BELLEFONTE COMBINED LICENSE APPLICATION – RESPONSE TO ENVIRONMENTAL REPORT REQUEST FOR ADDITIONAL INFORMATION – CORMIX-RELATED HYDROLOGY INFORMATION

Responses to Environmental Report Requests for Additional Information – CORMIX-Related Hydrology Information

NRC RAI NUMBER: 5.2-5, 5.3-3(2), 5.3-3(3), 5.3-5, and 5.3-8

NRC RAI NUMBER: 5.3-2 and 5.3-3 (1)

ATTACHMENT 5.3-3(1)A

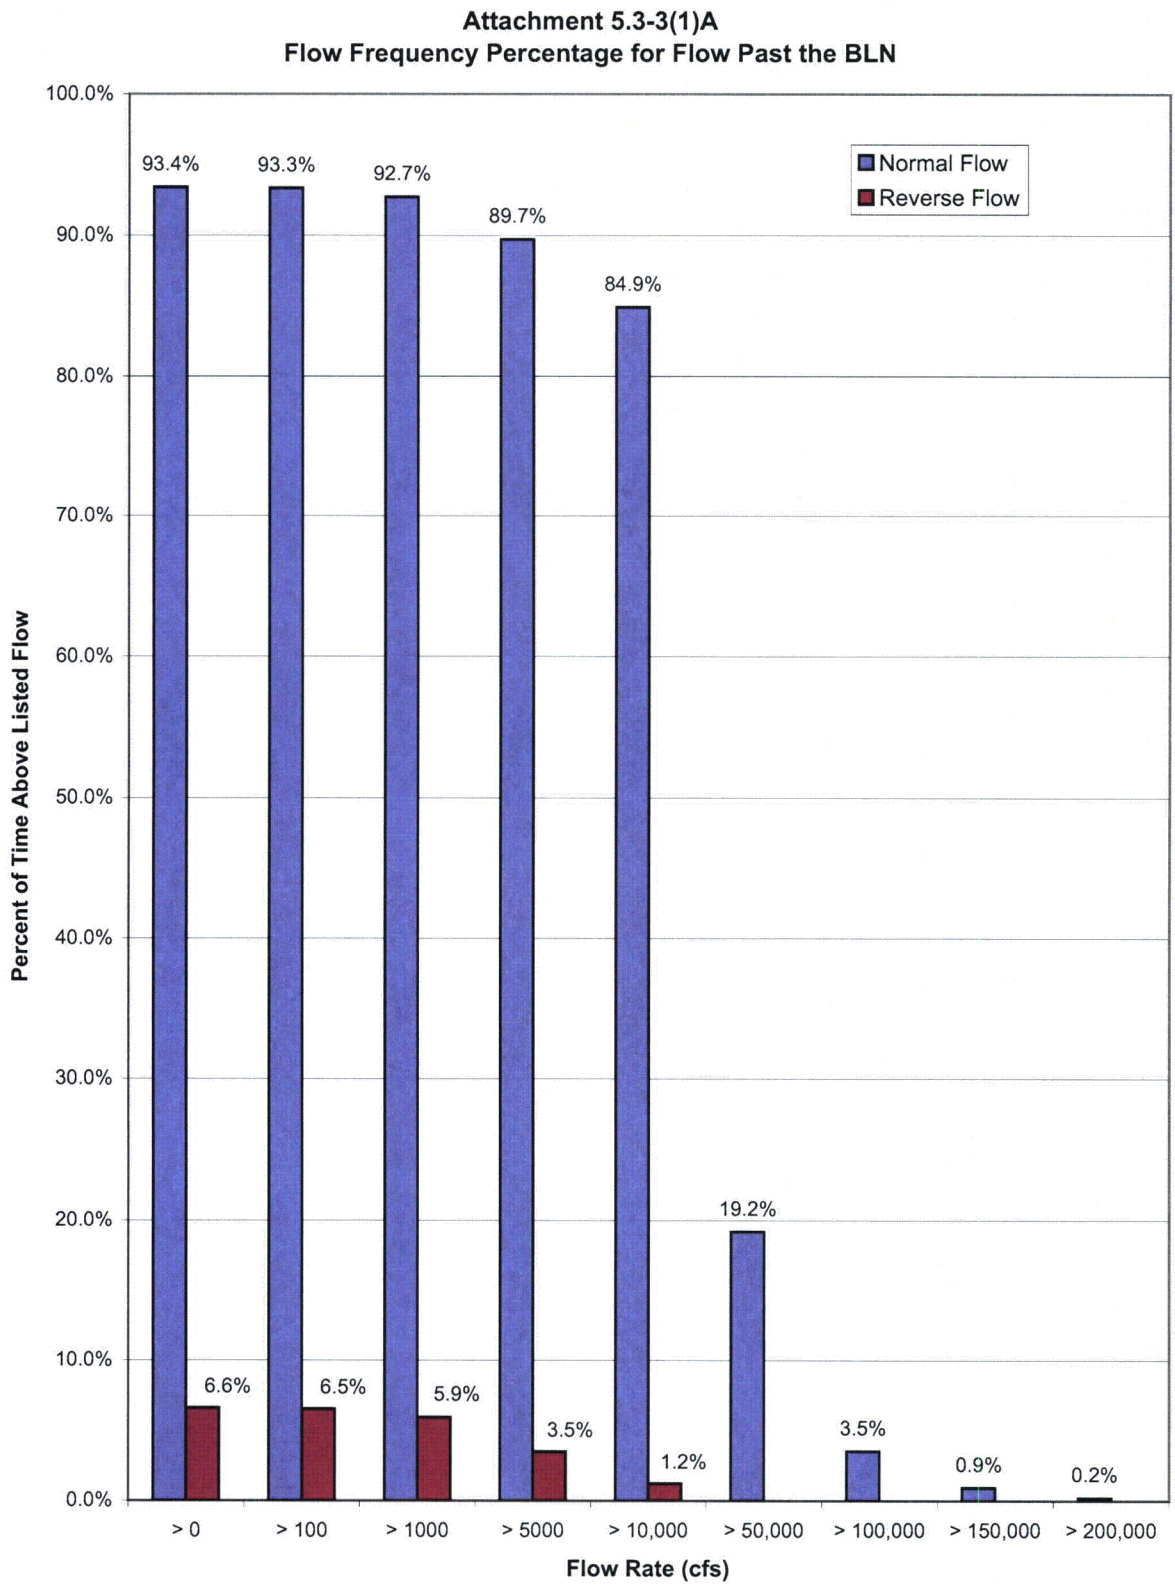
5.3-3: (1) Provide data or an analysis of flow reversal at the Bellefonte site that better characterizes the flow reversal phenomena. Use the existing reservoir operation rules and any future anticipated changes to peaking strategy to evaluate these phenomena.

The percentage of time exceeding specific flow rates is shown in Attachment 5.3-3(1)A. Normal river flow direction was shown to occur approximately 93 percent of the time, with flow exceeding 10,000 cfs (normal) approximately 85 percent of the time. Reverse river flow direction was shown approximately 7 percent of the time, with flow exceeding 1000 cfs (reverse) approximately 6 percent of the time.

FIGURE 5.3-3
100% EFFLUENT FLOW THROUGH BOTH DIFFUSERS - 7Q10 RIVER FLOW (39.2°F)

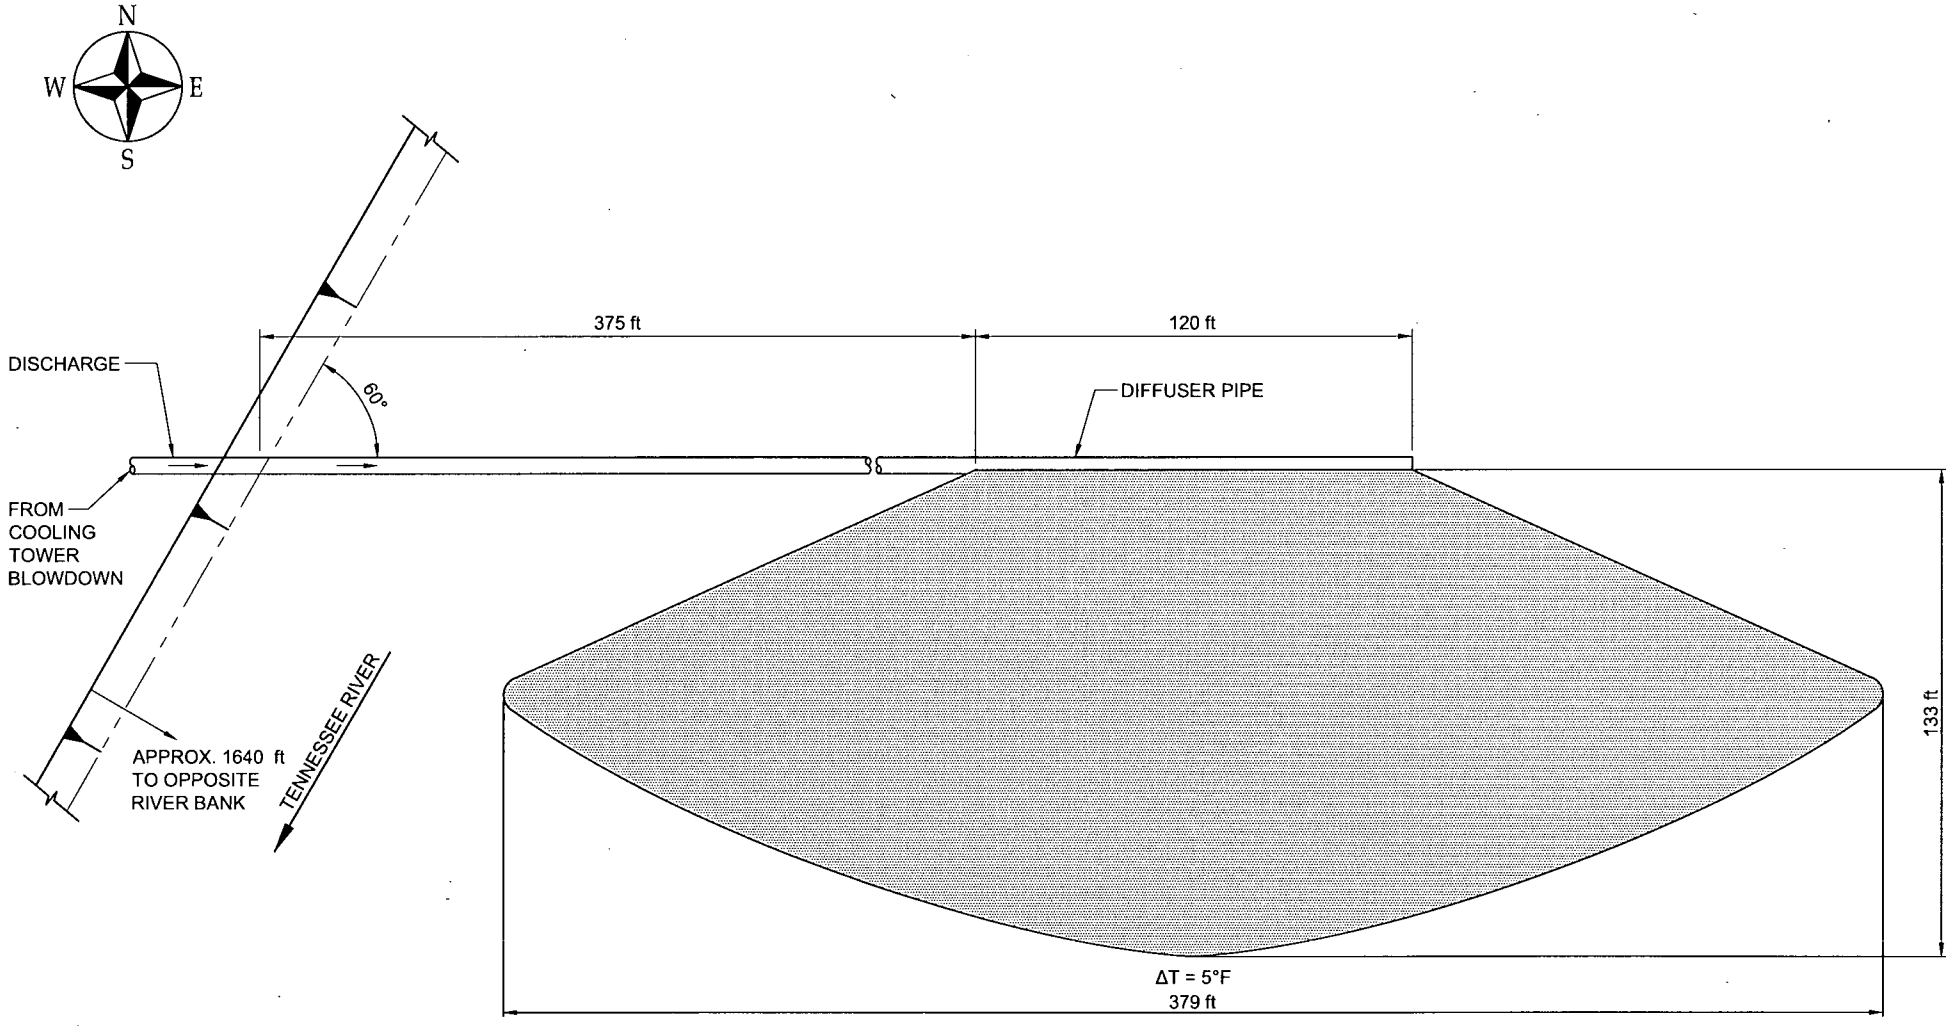
5.3-5: (1) Review and revise Figures 5.3-3 through 5.3-11; for clarity, draw them all to scale or none to scale.

(2) For these figures, use a consistent unit convention (English or Metric).

7. Change COLA Part 3, ER Chapter 5, by **replacing existing** Figure 5.3-3, Rev. 0, **with Figure 5.3-3, Rev. 1**, 100% Effluent Flow through Both Diffusers – 7Q10 River Flow (39.2°F), provided as Attachment 5.3-5A.
